PIC24FJ256DA210 Family Silicon Errata and Data Sheet Clarification

The PIC24FJ256DA210 Family devices that you have received conform functionally to the current Device Data Sheet (DS39969B), except for the anomalies described in this document.

Data Sheet Clarifications

FIGURE 2-3 FREQUENCY vs. ESR PERFORMANCE FOR SUGGESTED VCAP

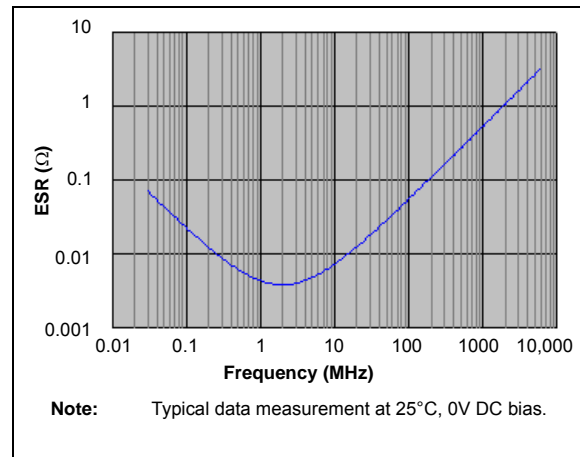
Section 2.4 Voltage Regulator Pins (ENVREG/DISVREG and VCAP/VDDCORE) has been replaced with a new and more detailed section. The entire text follows:

When the regulator is enabled, a low-ESR ($< 5\Omega$) capacitor is required on the VCAP pin to stabilize the voltage regulator output voltage. The VCAP pin must not be connected to VDD and must use a capacitor of $10\ \mu\text{F}$ connected to ground. The type can be ceramic or tantalum. Suitable examples of capacitors are shown in Table 2-1. Capacitors with equivalent specifications can be used.

Designers may use Figure 2-3 to evaluate ESR equivalence of candidate devices.

FIGURE 2-4 DC BIAS VOLTAGE vs. CAPACITANCE CHARACTERISTICS

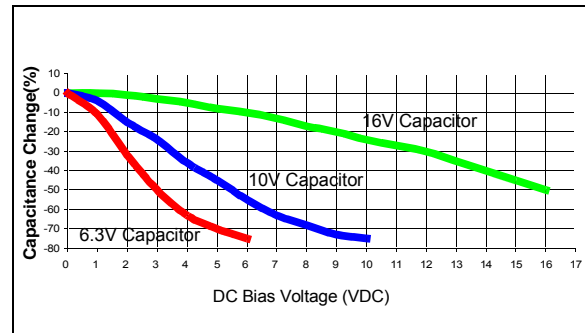
A typical DC bias voltage vs. capacitance graph for 16V, 10V and 6.3V rated capacitors is shown in Figure 2-4.

When selecting a ceramic capacitor to be used with the internal voltage regulator, it is suggested to select a high-voltage rating, so that the operating voltage is a small percentage of the maximum rated capacitor voltage. For example, choose a ceramic capacitor rated at 16V for the 1.8V V_{CAP} voltage. Suggested capacitors are shown in Table 2-1.

FIGURE 30-1: PIC24FJ256DA210 FAMILY VOLTAGE-FREQUENCY GRAPH (INDUSTRIAL)

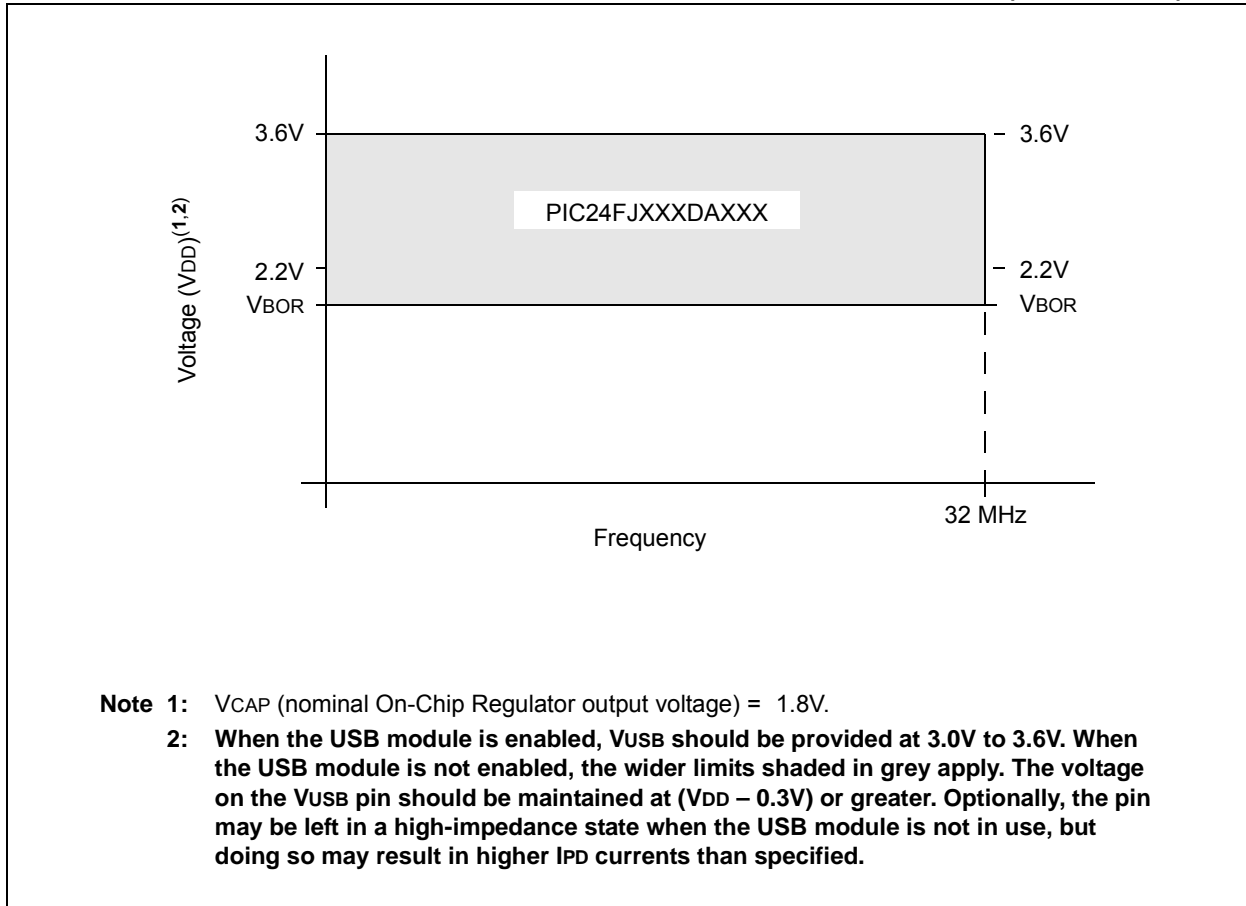
Figure 30-1 (“PIC24FJ256DA210 Family Voltage-Frequency Graph”) is amended by adding an additional footnote. The updated figure is shown below (changes in **bold**; bold in original removed for clarity).
